City Council
CITY HALL COUNCIL CHAMBERS
REGULAR AGENDA OF APRIL 21, 2025
7:00 PM

**NORTH RIDGEVILLE PLANNING COMMISSION
MINUTES OF REGULAR MEETING
TUESDAY, APRIL 8, 2025**

Planning Review

SHEET: C2.0

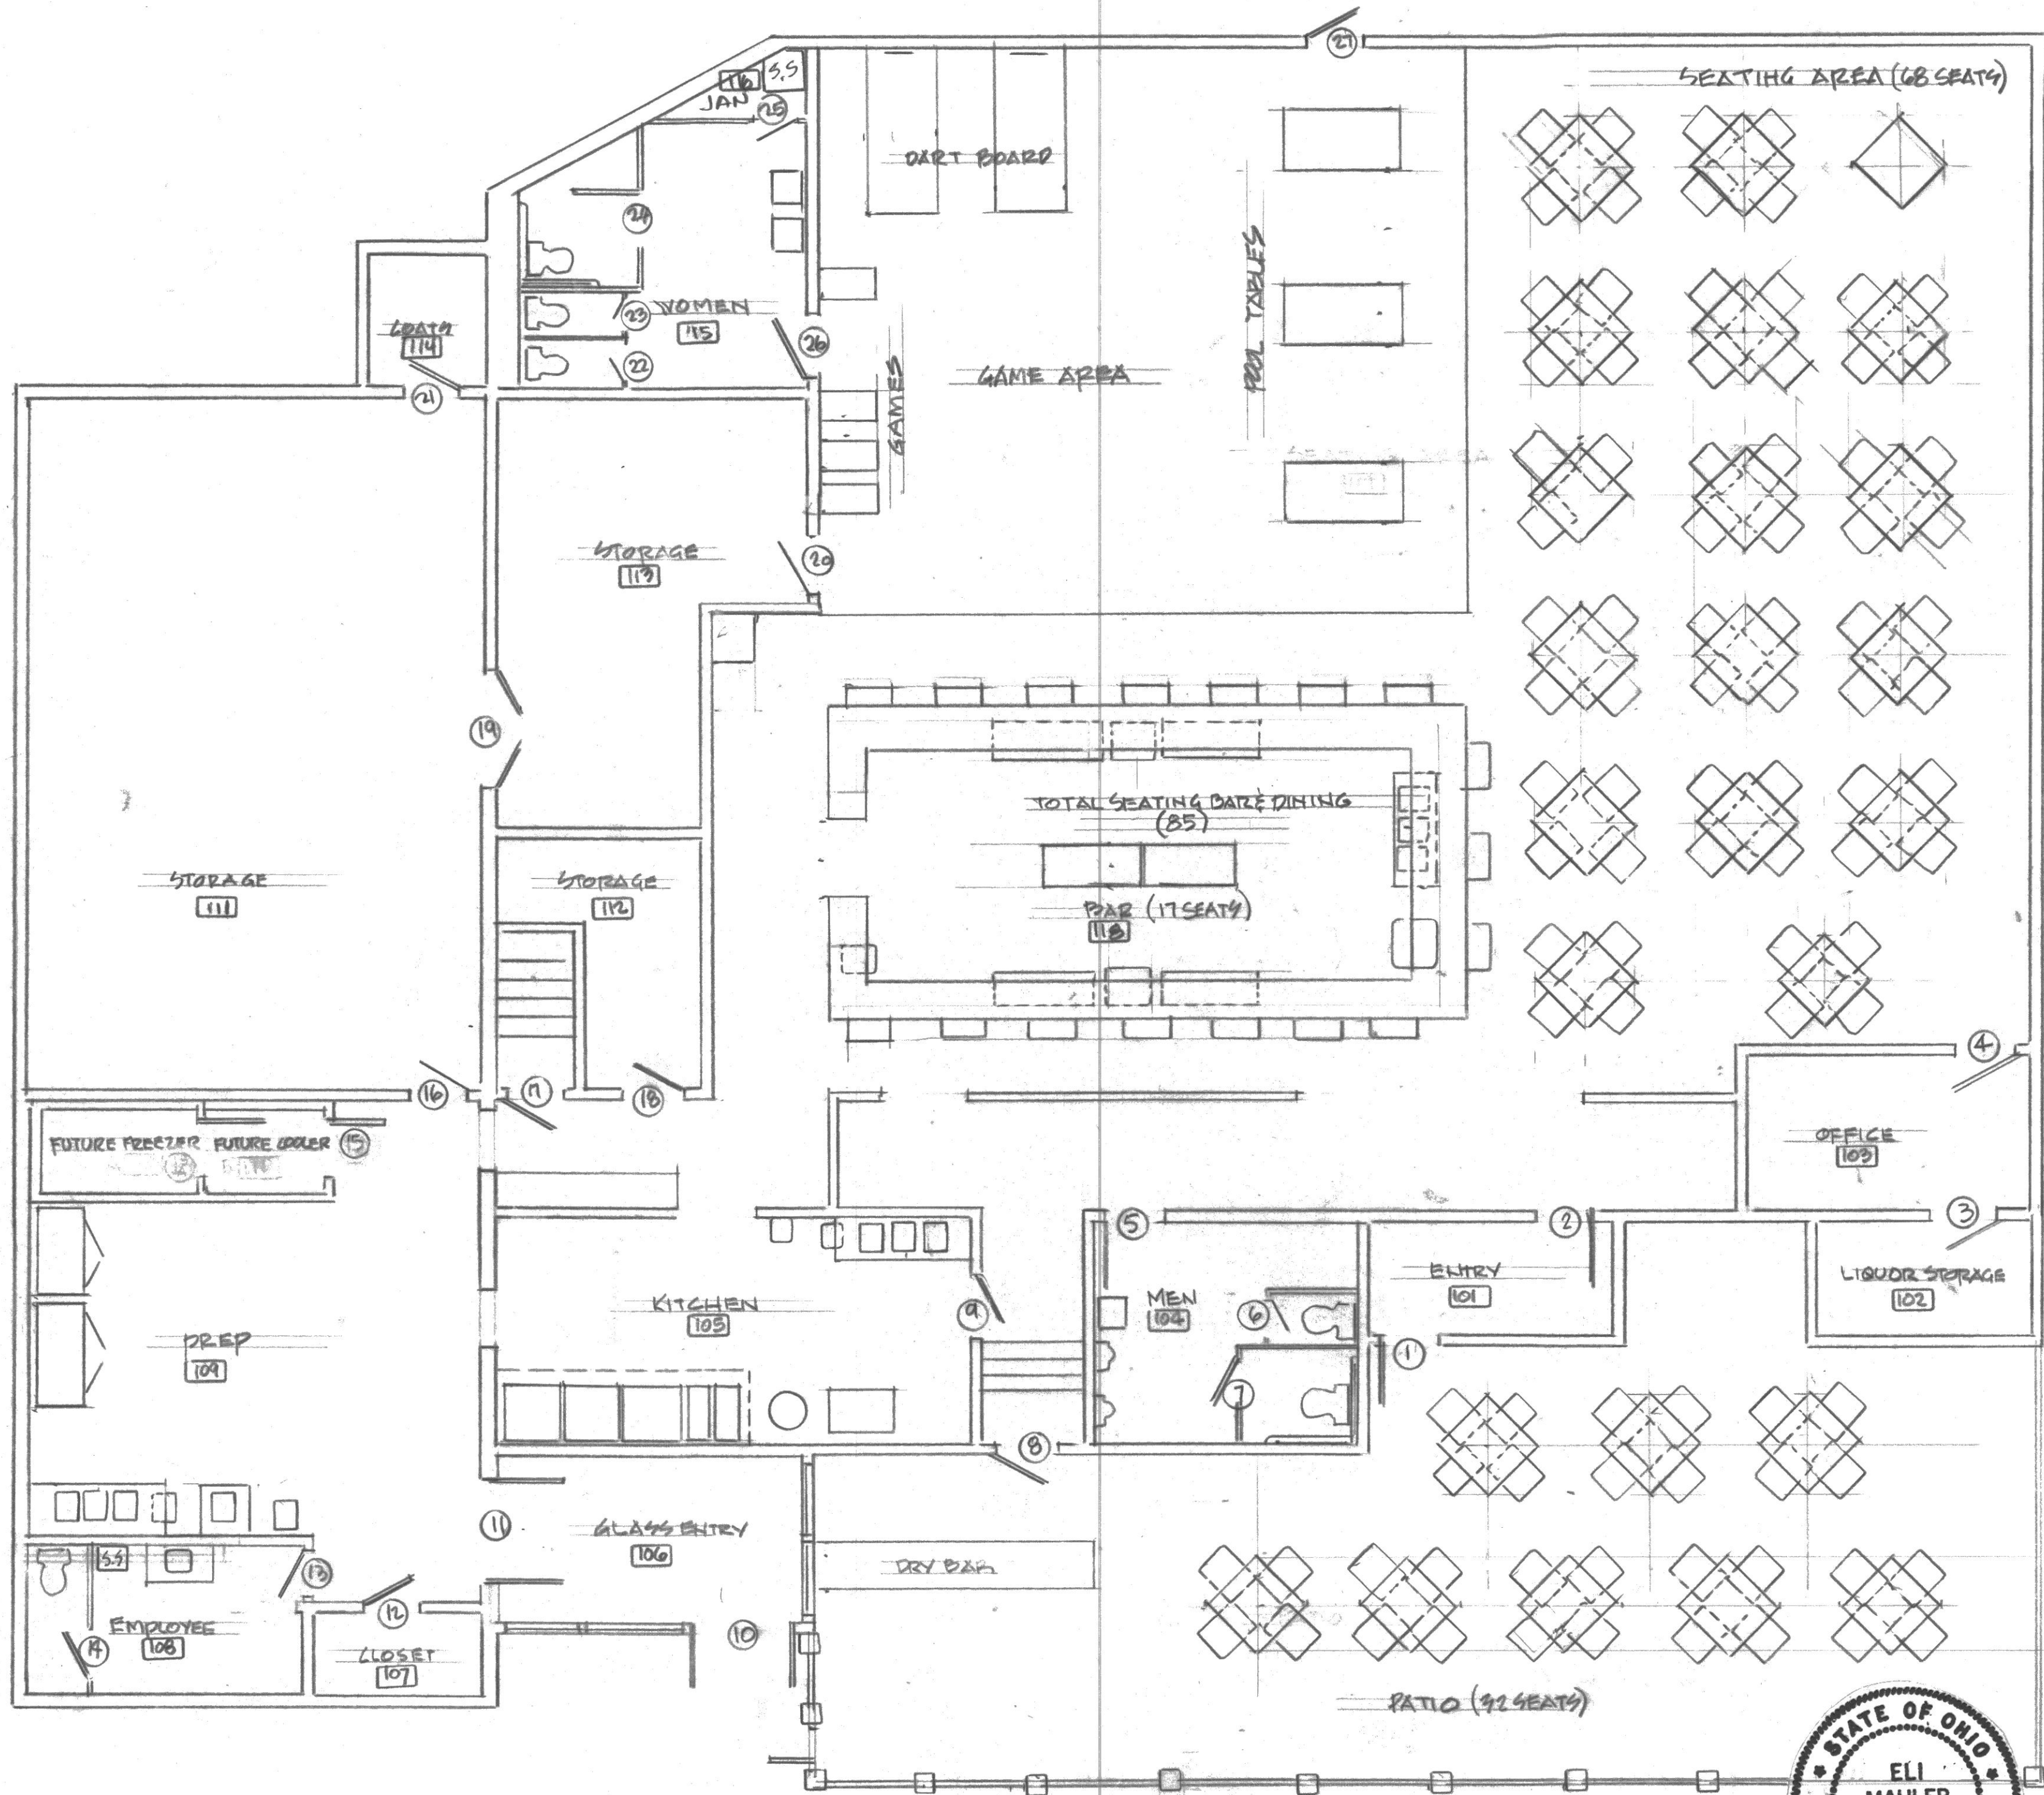
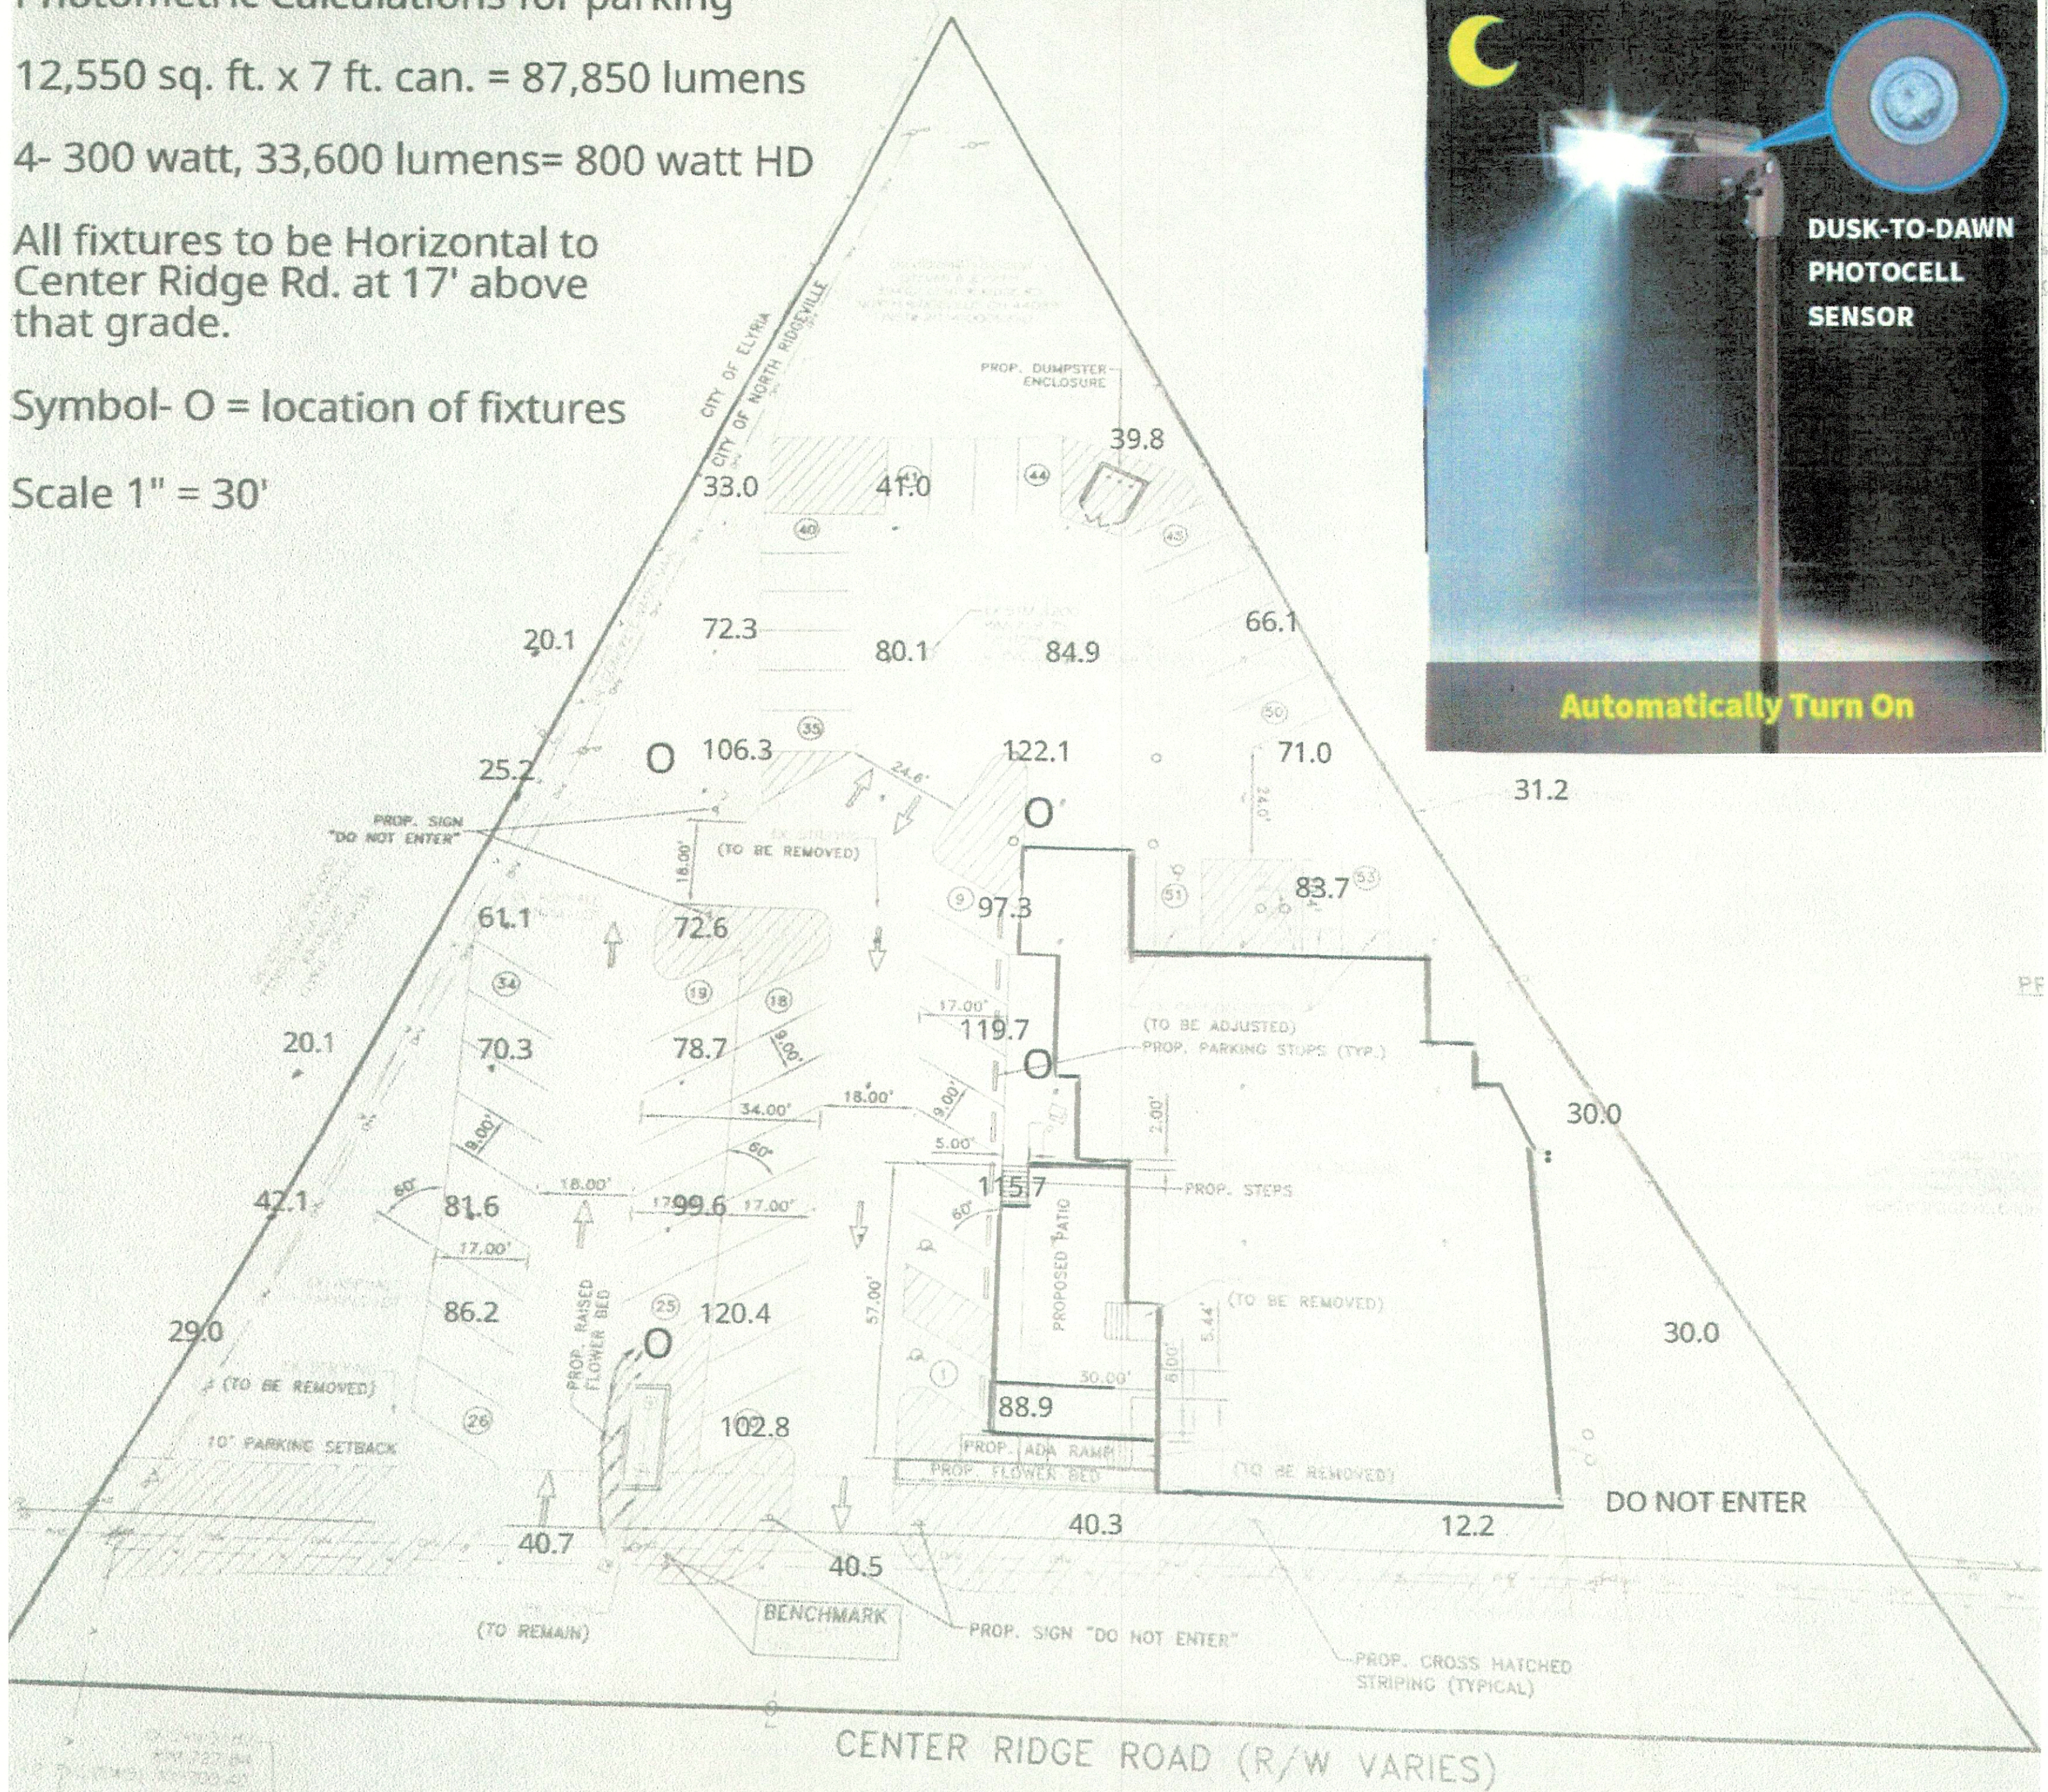
- Relocate ingress curb cut further west to provide greater separation from utility pole and hydrant in ROW.
 - Curb cut moved as a result of additional striping around landscape area. Greater protection would be afforded by expanding the raised landscape area, not just adding striping. Parking configuration has been re-angled along west property line.

- Indicate parking lot is to be *patched*, sealed and restriped on site plan.
 - Note updated.
- Provide more detail on the elevations to include proposed colors, materials and construction detail.

- Proposed planter spec and shrub provided.
- Ensure railing is provided around entire patio portions above grade.
 - Railing shown around entire patio (on photometric plan). Clarify which type of railing is proposed (vertical rail or horizontal rail).

- Photometric plan and light fixtures are needed for review.
 - Photometric plan not presented according to code requirements (footcandles on 10-foot square grid overlaying site plan). Light fixture shown at angle (not full cut off) though light plan says fixtures to be horizontal.

1. Curbing shall be modified to sufficiently protect utility pole and fire hydrant per Engineering requirements.
 2. Administrative approval is required for the lighting plan and photometrics.
